SUBDIVISION REVIEW SHEET**CASE NO.:** C8-2018-0165.4A**COMMISSION DATE:** July 26, 2022**SUBDIVISION NAME:** Cascades at Onion Creek East, Phase Four**ADDRESS:** 11601 S. IH 35 SVRD NB**APPLICANT:** M/I Homes of Austin, LLC (William G. Peckman)**AGENT:** LJA Engineering (Russell W. Kotara, P.E.)**ZONING:** I-SF-2 (single family)**NEIGHBORHOOD PLAN:** Southeast**AREA:** 22.34 acre (973,130 sf)**LOTS:** 110**COUNTY:** Travis**DISTRICT:** 5**WATERSHED:** Onion Creek**JURISDICTION:** Full Purpose**SIDEWALKS:** Sidewalks will be constructed along streets.**VARIANCE:** None**DEPARTMENT COMMENTS:**

CITY OF AUSTIN –DEVELOPMENT SERVICES DEPARTMENT
SUBDIVISION APPLICATION – MASTER COMMENT REPORT

PROJECT NAME: Cascades at Onion Creek East, Phase Four Final Plat
LOCATION: 11601 S IH 35 SVRD NB

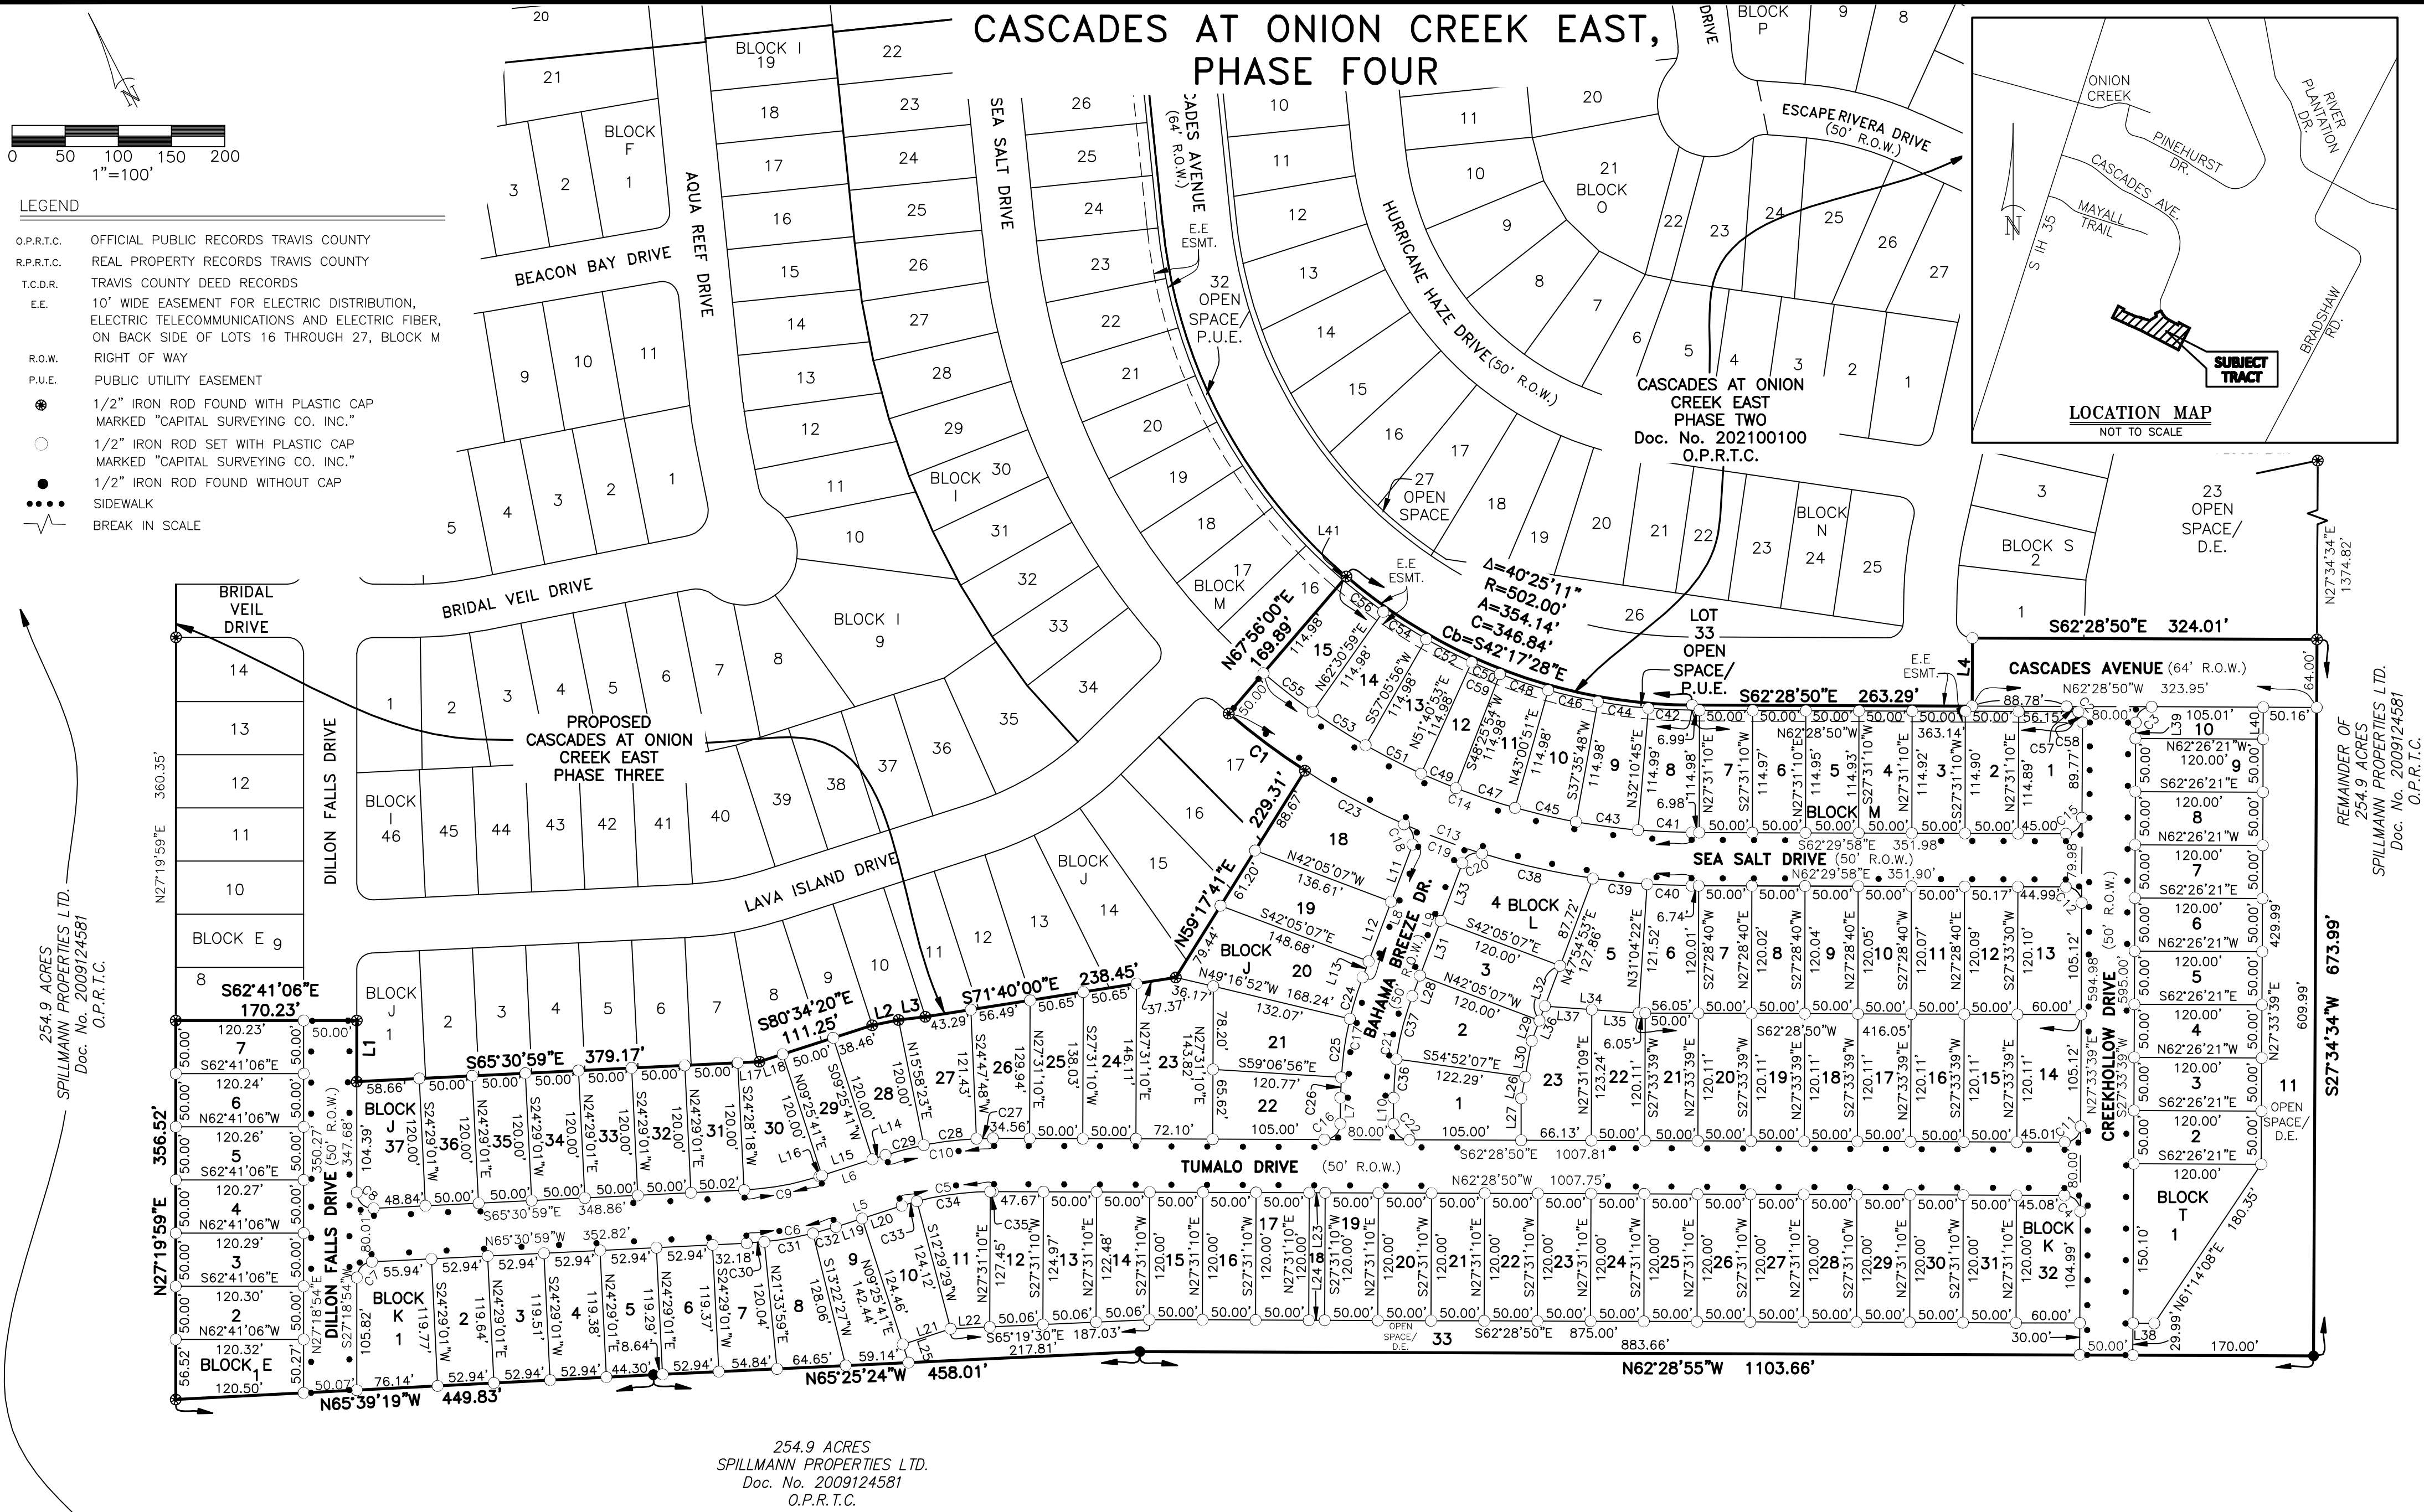
SR 6. Label the lots on Sheet 2 that will have open space or other nonresidential uses. 25-1-83, 30-1-113

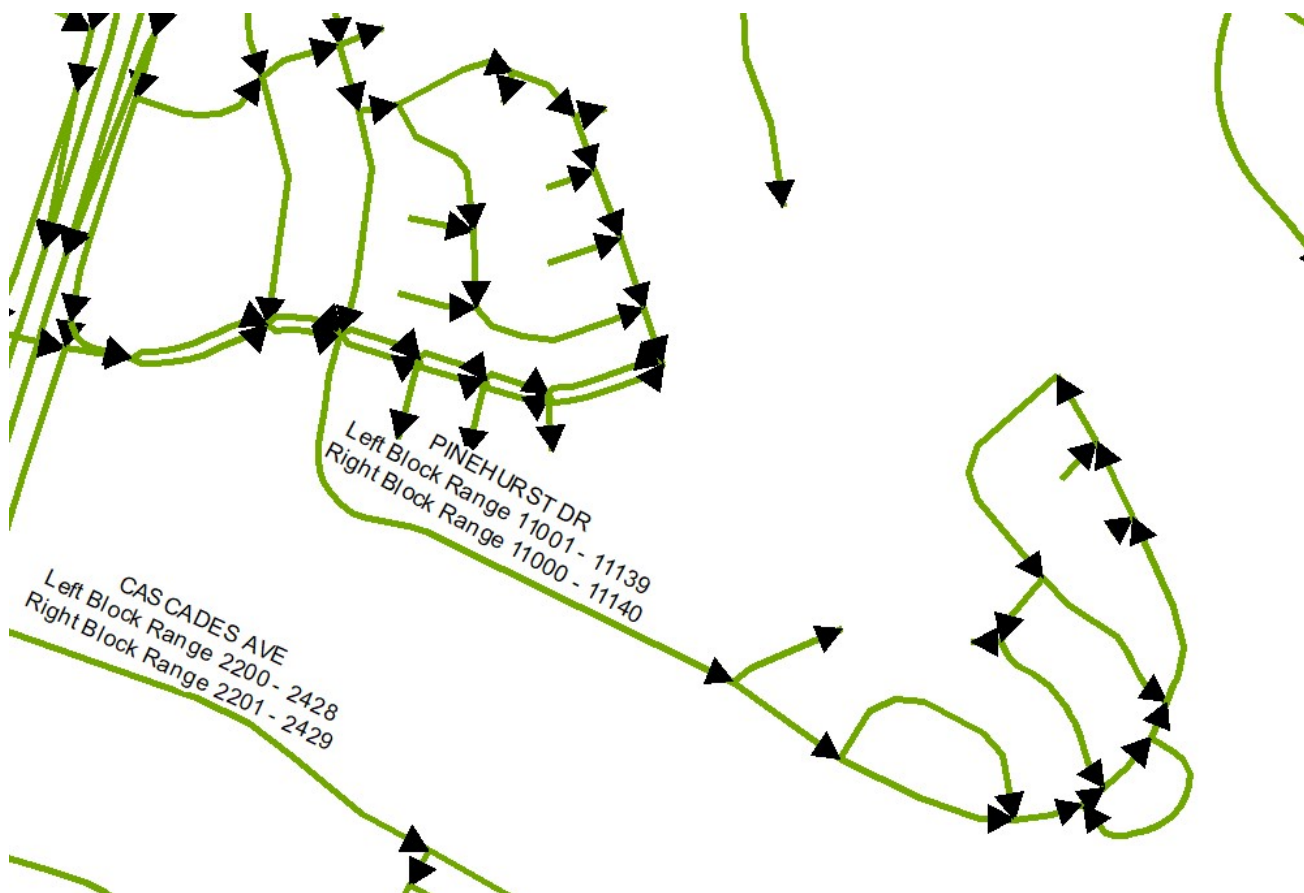
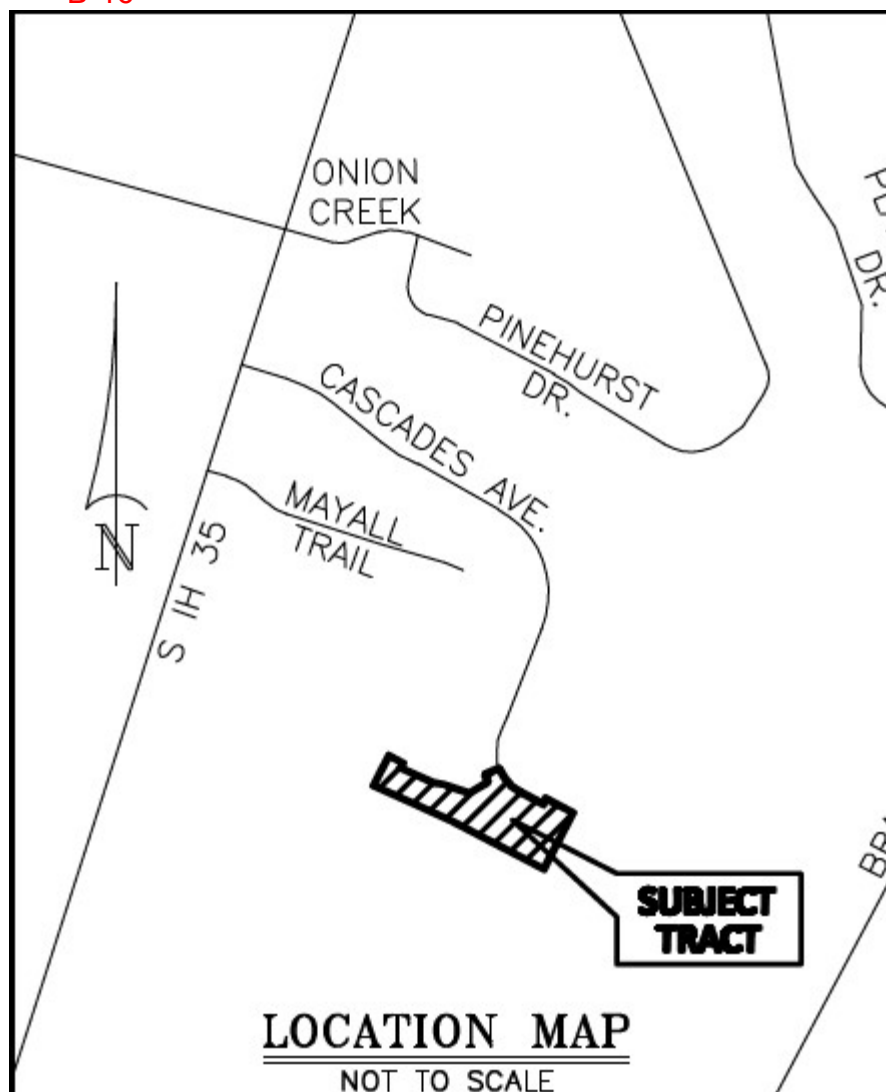
AD4: Please update label to read as follows **ONION CREEK PKWY** in the location map. The street is missing the street type

AD5: PINEHURST DR does not exist north of ONION CREEK PKWY, please correct the linework

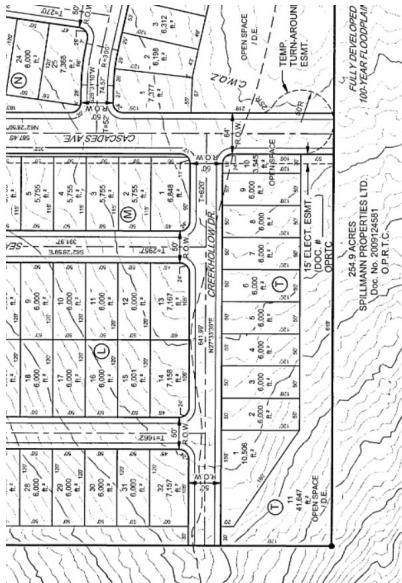
EV 0 Note #23 states: *"Waterway setbacks as defined by the Land Development Code may be located on this property. Development is limited within waterway setbacks."* [LDC 25-8, Article 7] However, the preliminary plan does not show a CWQZ in the section that is included in this plat. Explain why the CWQZ appears to stop at Cascades Ave. in the preliminary plan (first clip) and is not shown as it is in Property Profile (second clip) and in the ERI (third clip).
